Access Compliance Report

Public Rights-of-Way

(Curb Ramps)

Intersection ID: 17596	Main Street: WATER_OAK_RD	Cross Street: N_SHARON_AMITY_RD	Location: SE
ADA ID: FDCD2D2E47C2	Ramp Type: PerpDiag	Initial Pass/Fail: Fail	Overall Compliance: No
Severity Score: 21.25			
Codes/Mitigation Info/Possible Solution		Field Measurements/Component Compliance

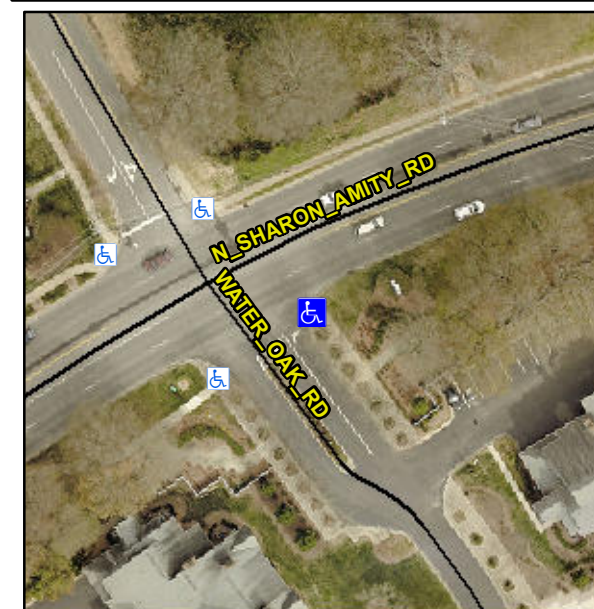
Not Found, R304.5.1, R304.5.3

Compliance	Description	Data	Compliance	Description	Data
N/A	Ramp Length (in)	40.0	Yes	Ramp Slope (%)	7.9
No	Ramp Width (in)	42.0	No	Ramp XSlope (%)	5.2
N/A	Flare Type LT	N/A	N/A	Flare Type RT	N/A
N/A	Flare Slope LT (%)	N/A	N/A	Flare Slope RT (%)	N/A
N/A	Flare Traversable LT?	N/A	N/A	Flare Traversable RT?	N/A
N/A	Landing Length (in)	N/A	N/A	DWS Provided?	N/A
N/A	Landing Width (in)	N/A	N/A	DWS Contrast?	N/A
N/A	Landing Slope (%)	N/A	N/A	DWS Length (in)	N/A
N/A	Landing X Slope (%)	N/A	N/A	DWS Full Width?	N/A
N/A	Landing Curb? (Y/N)	N/A	N/A	DWS Offset (in)	N/A
N/A	Shared Landing?	N/A			
N/A	Gutter Ponding?	N/A	N/A	Gutter Slope (%)	N/A
N/A	Gutter Lip Ht (in)	N/A	N/A	Gutter X Slope (%)	N/A
N/A	Painted X Walk1?	No	N/A	Painted X Walk2?	No
	X Walk 1 Direction	To NW		X Walk 2 Direction	To SW
N/A	X Walk 1 Width (in)	N/A	N/A	X Walk 2 Width (in)	N/A
	X Walk 1 Slope (%)	5.8		X Walk 2 Slope (%)	1.6
	X Walk 1 X Slope (%)	0.1		X Walk 2 X Slope (%)	1.4

Remove & Replace Curb Ramp With Two New Directional Ramps or Equivalent.
